GROUP	MODEL
CHA	2019-2024MY Multiple Models
NUMBER	DATE
121	January 2024

TECHNICAL SERVICE BULLETIN

SUBJECT: FRONT STRUT BEARING & SPRING PAD REPLACEMENT

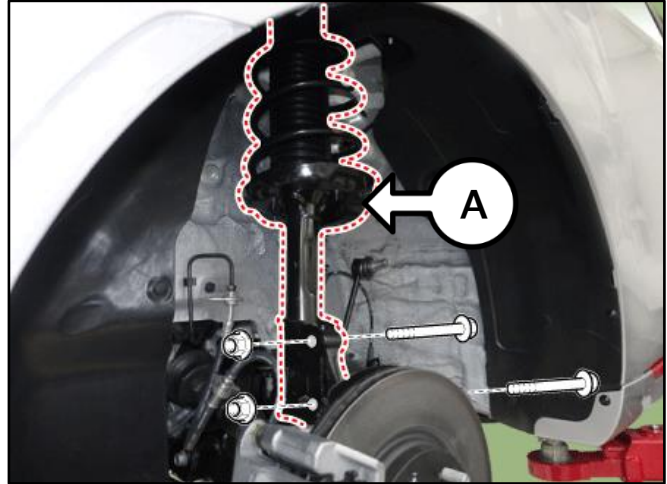
1. Remove the front strut assembly (A), both left and right side, by referring to "Suspension System → Front Suspension System → Front Strut Assembly/Front Strut Complete → Repair Procedures (Removal and Installation)" in the shop manual on KGIS.

2. Disassemble one of the front strut assemblies (A) by referring to "Suspension System → Front Suspension System → Front Strut Complete → Repair Procedures (Disassembly)" in the shop manual on KGIS.

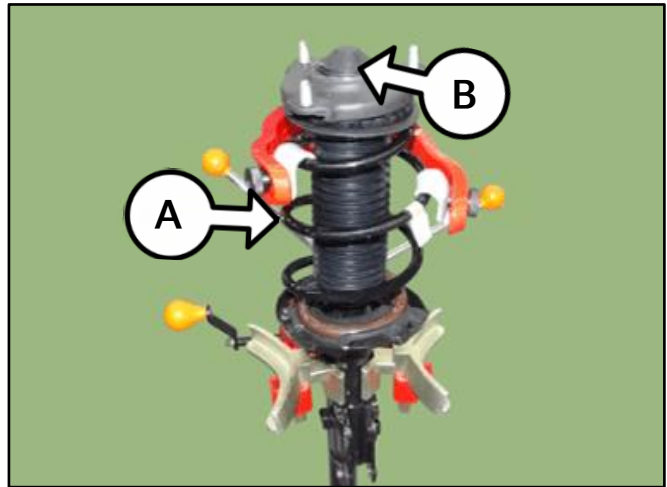
Note: SST 09546 3X100 is required to loosen the self locking nut (B). **DO NOT reuse the removed locking nut (discard after removal).**

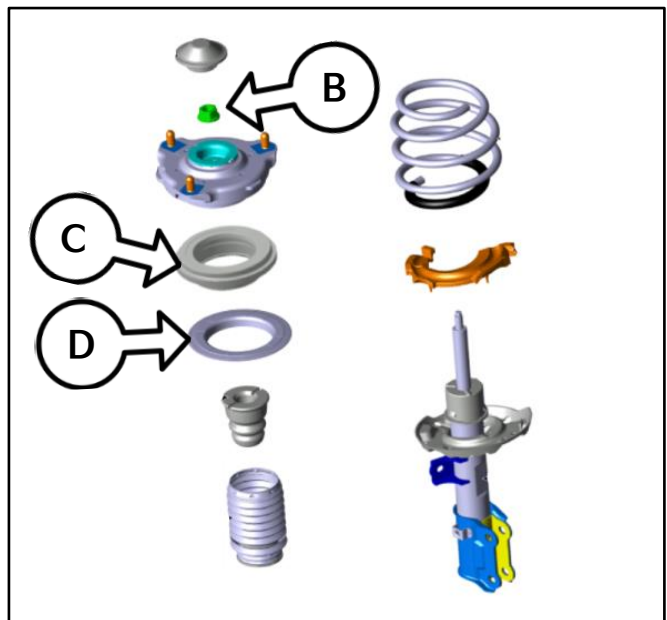
3. Replace the strut bearing (C) and the spring pad (D) with the new parts.

Note: INSTALL a 'new' locking nut (B).

Tightening torque for locking nut (B):
39.8 - 54.2 lb.ft (53.9 - 73.5 N.m)
